**STATE OF TENNESSEE  
DEPARTMENT OF TRANSPORTATION**

**INSTRUCTIONAL BULLETIN NO. 22-03**

**Regarding Various Revised and New Standard Drawings**

**Effective August 19, 2022 letting (June 8, 2022 Turn-in)**, the following Standard Drawings have been revised or are new. In addition, Chapter 10 of the Roadway Design Guidelines - Index of Standard Drawings and the web site have been updated accordingly and are available online.

BIKE AND PEDESTRIAN SAFETY RAIL

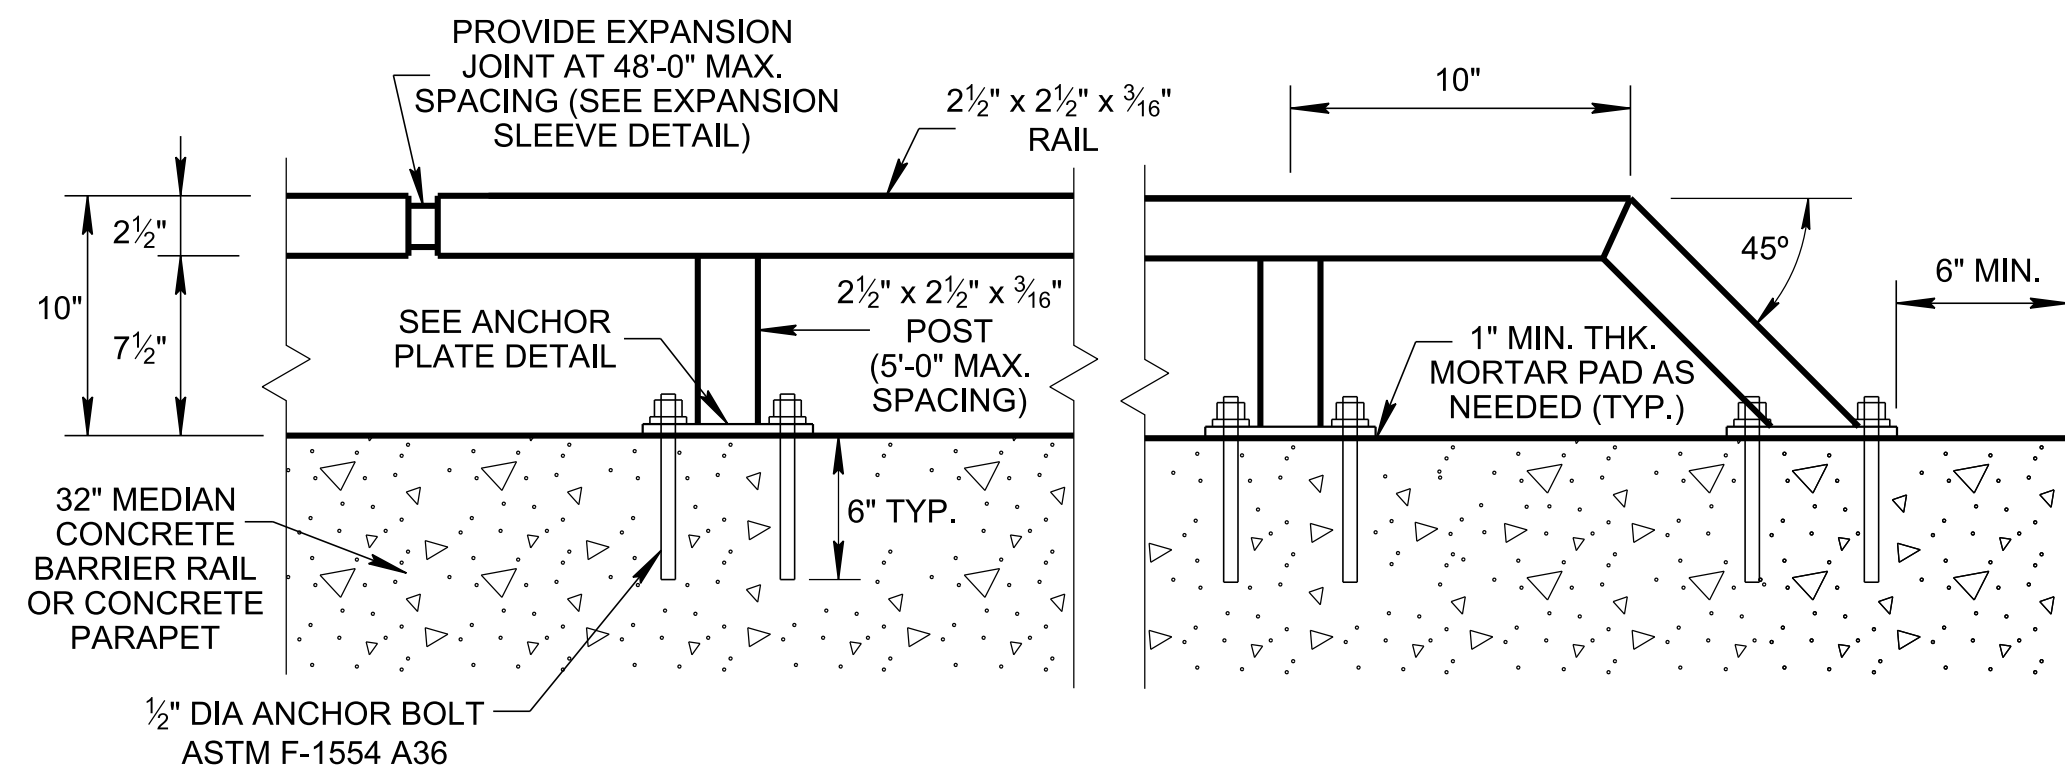
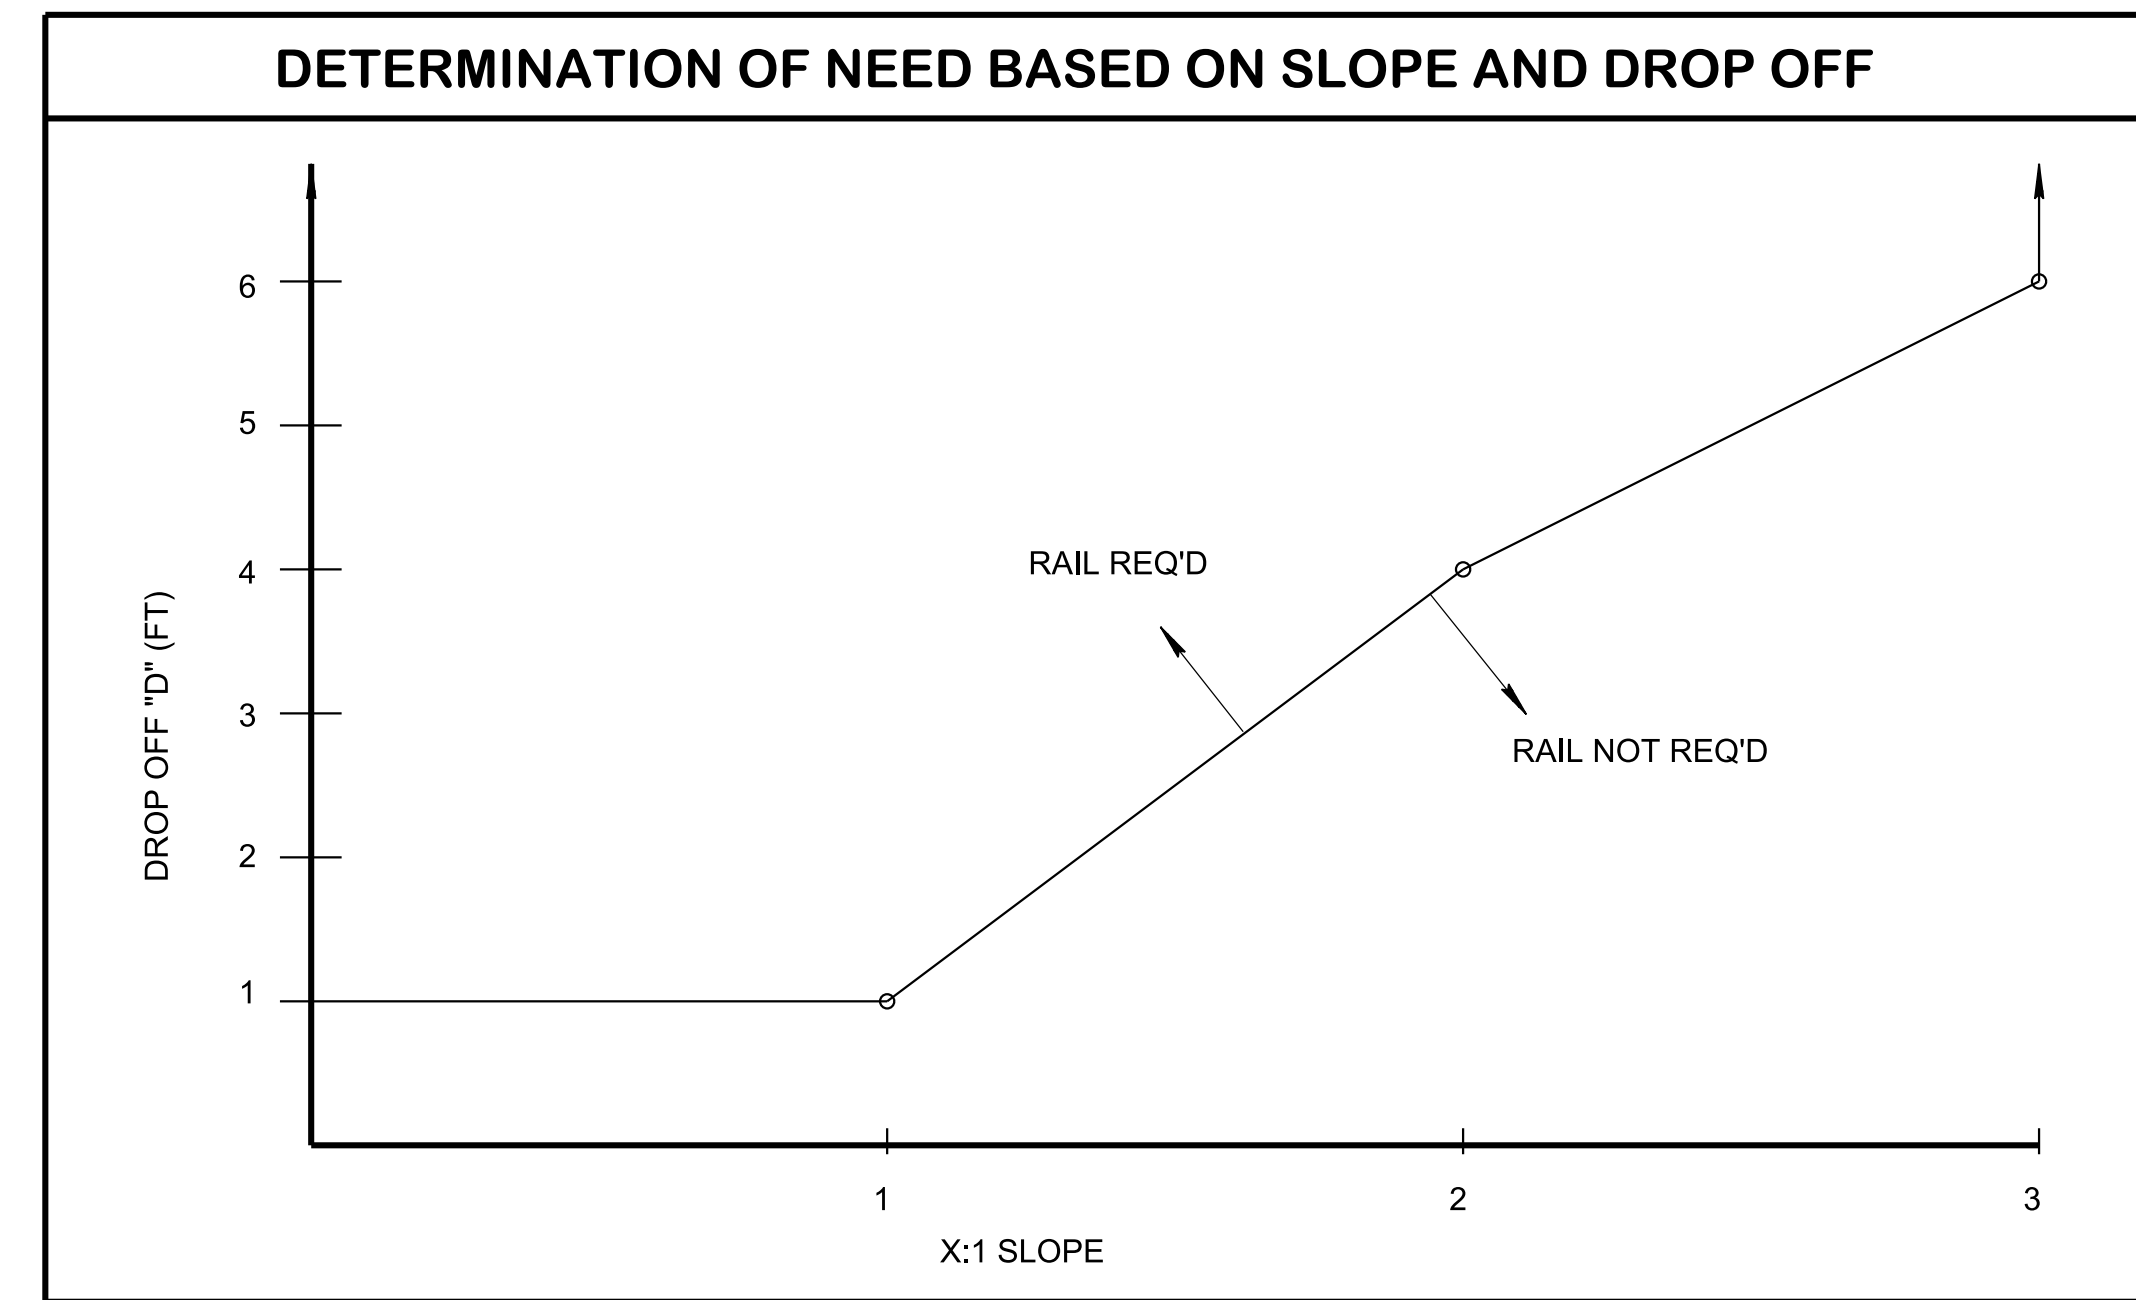
REV. 10-16-20: REVISED ANCHOR BOLTS SIZE. UPDATED GENERAL NOTE (D)  
 REV. 01-28-2022: ADDED SECTION VIEW FOR POST SET IN SIDEWALK, TYPICAL PLAN VIEW FOR SIDEWALK EXTENSION AT SAFETY RAIL, AND SAFETY RAIL INSTALLATION ON BIKE/PED 32" CONCRETE MEDIAN BARRIER RAIL OR PARAPET DRAWINGS. REMOVED ALTERNATE PLAN VIEW AND ALTERNATE INSTALLATION DRAWINGS. GENERAL NOTE (I) WAS ADDED. ADDED NOTE UNDER FIGURE 1.

**VEHICULAR BRIDGE TYPICAL SECTION WITH SIDEWALK OR SHARED USE PATH (SEE NOTE (P))**

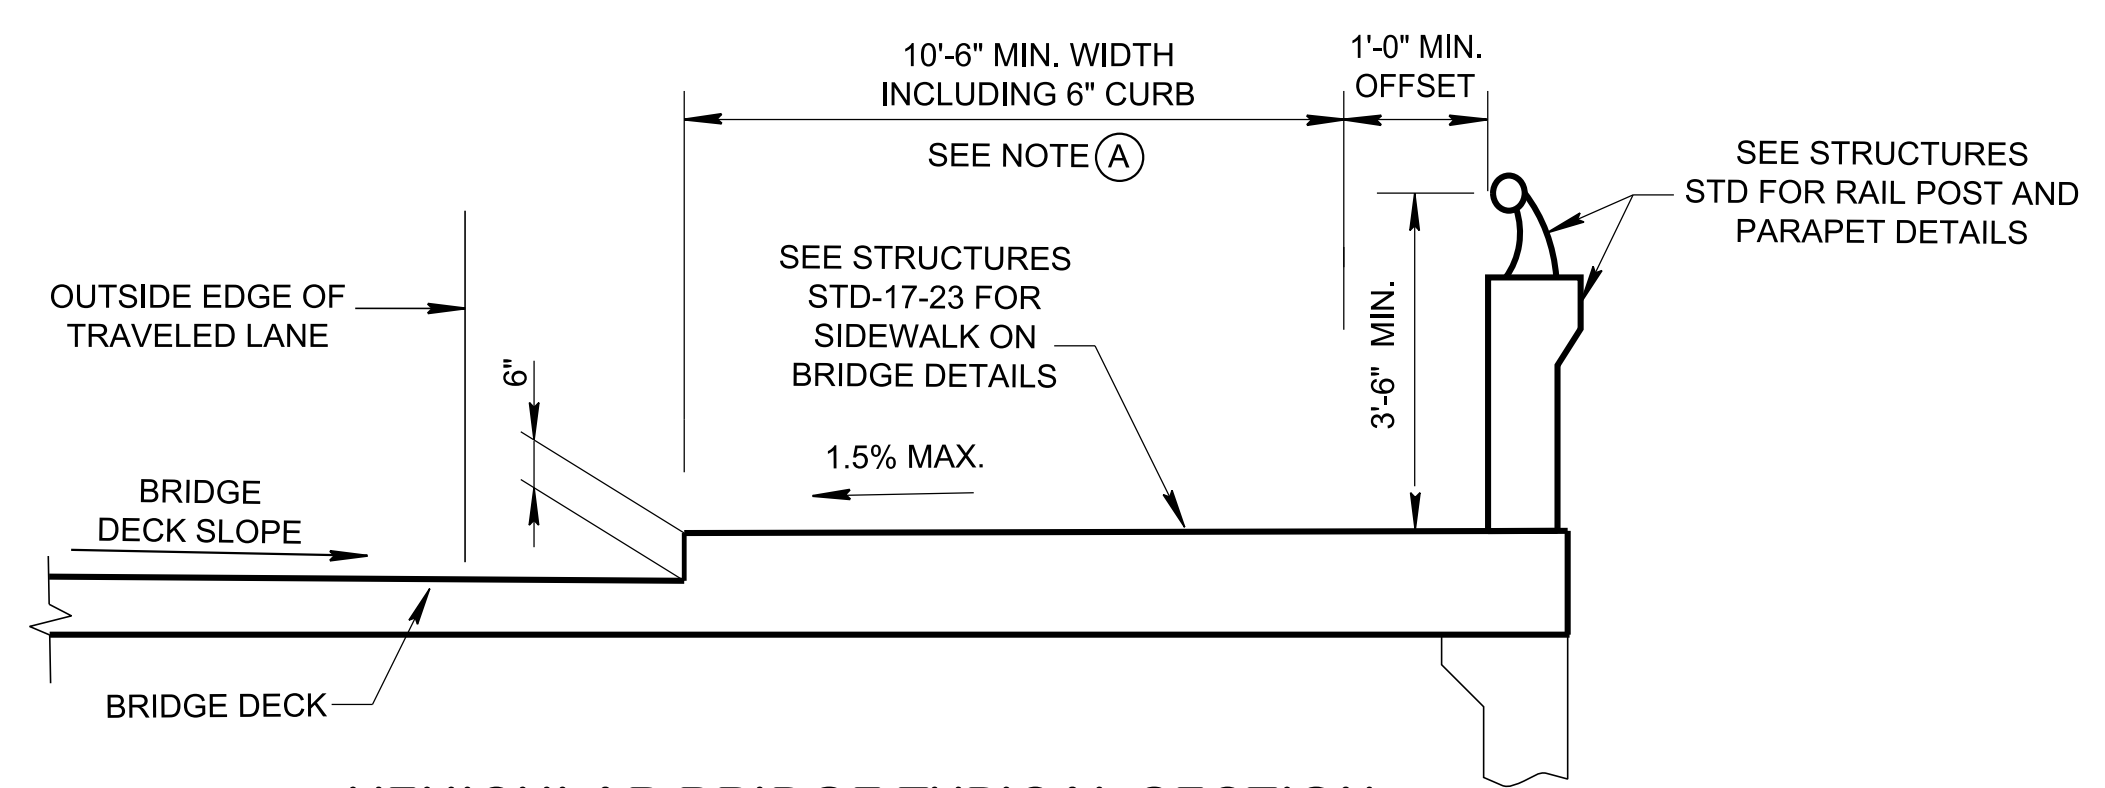
REV. 01-28-2022: ADDED VEHICULAR BRIDGE TYPICAL SECTION WHEN SIDEWALK PRESENT DRAWING. GENERAL NOTE (P) WAS ADDED. REVISED BRIDGE TYPICAL SECTION TITLES.

**PLAN**

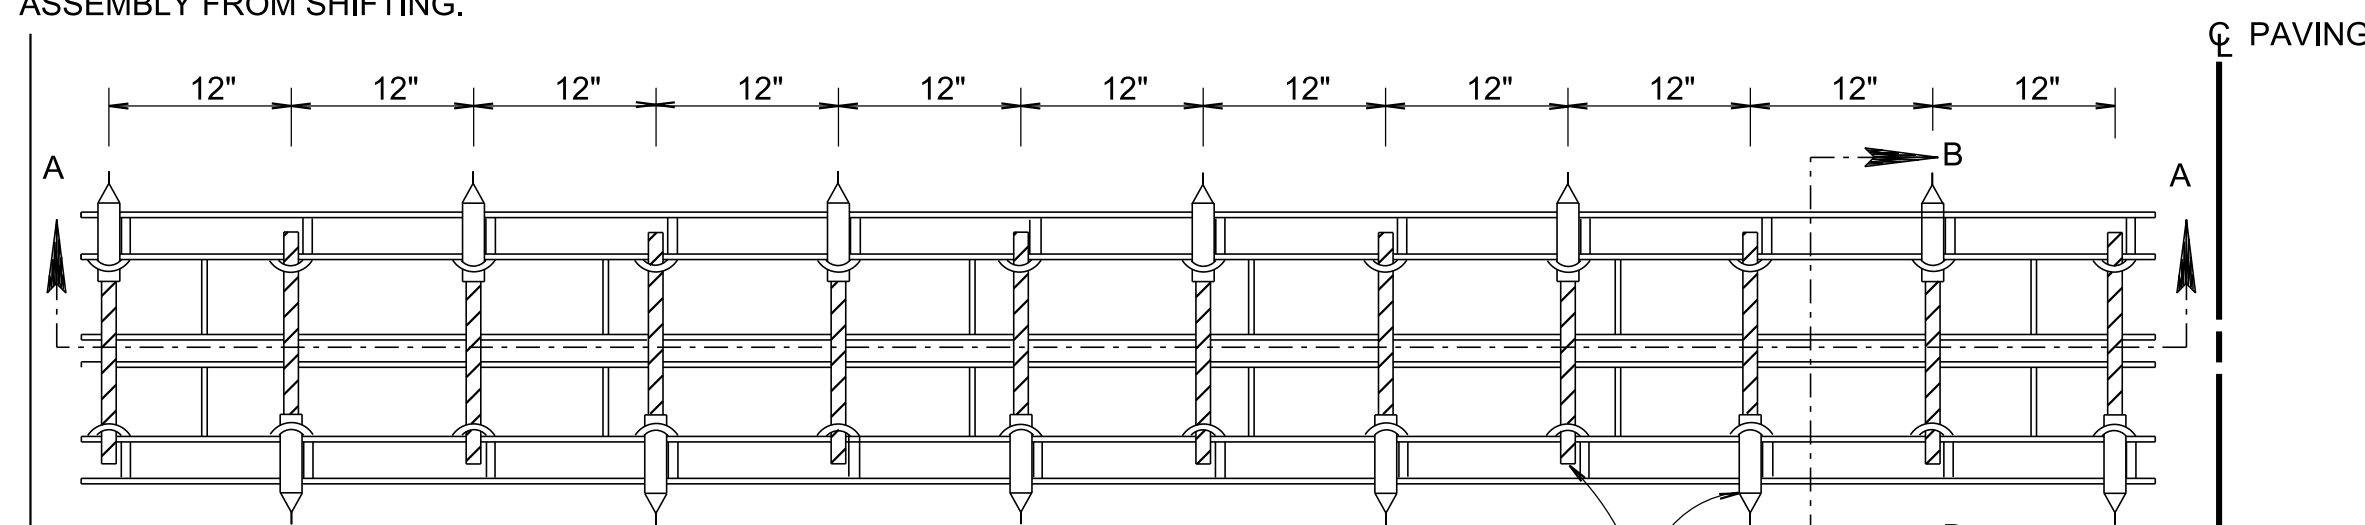
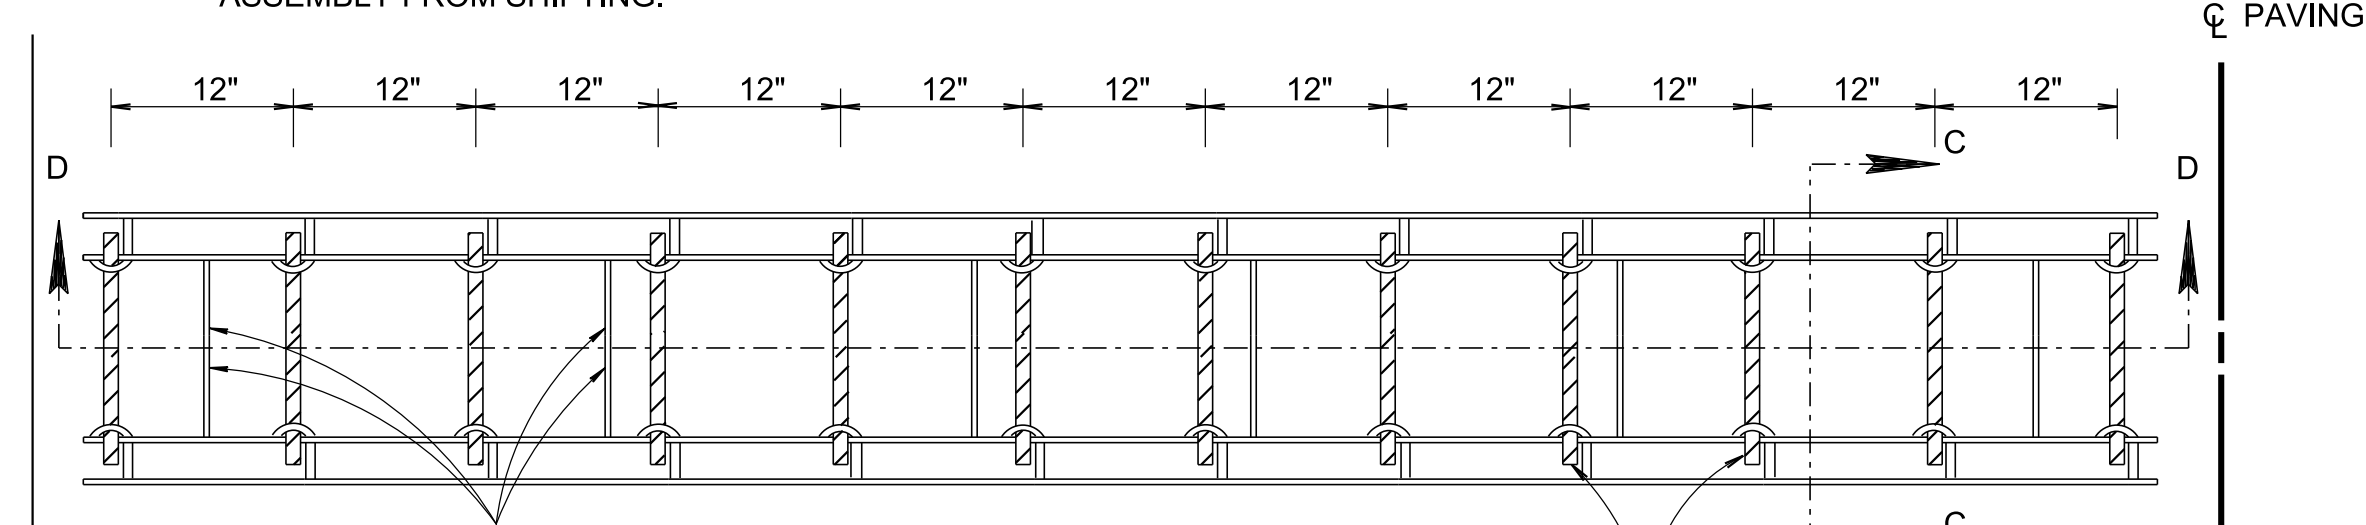
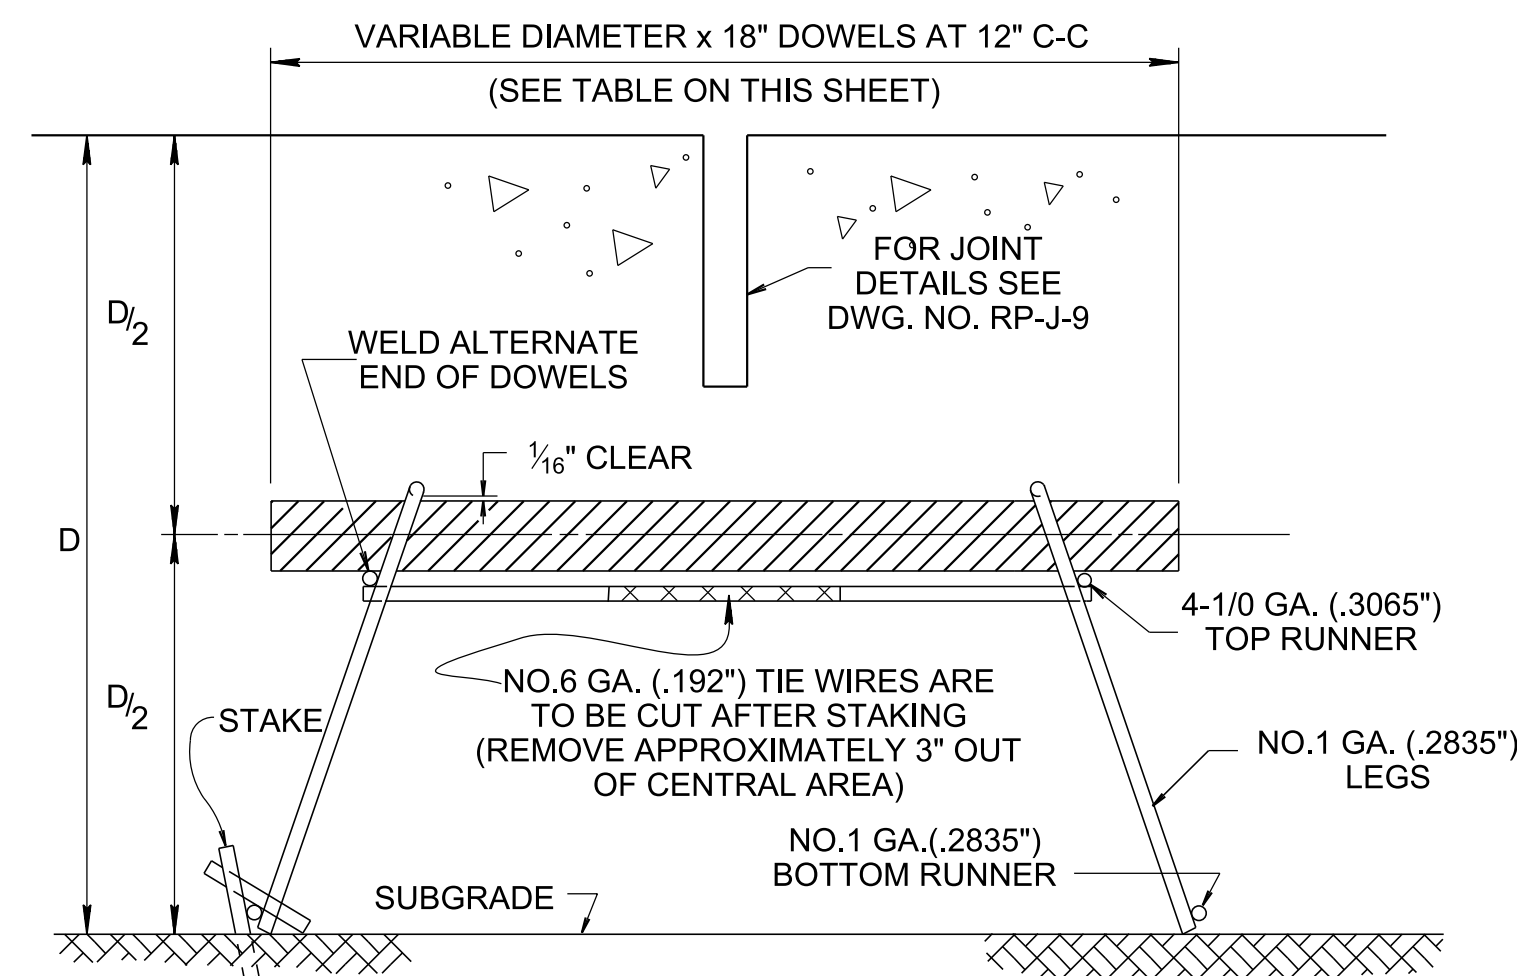
- REV. 2-2-12: CHANGED DOWEL BAR TABLE.
- REV. 05-01-20: REDREW SHEET.
- REV. 01-28-2022: ADDED NOTES ABOUT CUTTING OF TIE WIRE AFTER STAKING ON PLAN AND ON SECTION C-C.

CUT APPROXIMATELY 3" OUT OF CENTRAL AREA OF TIE WIRES AFTER STAKING
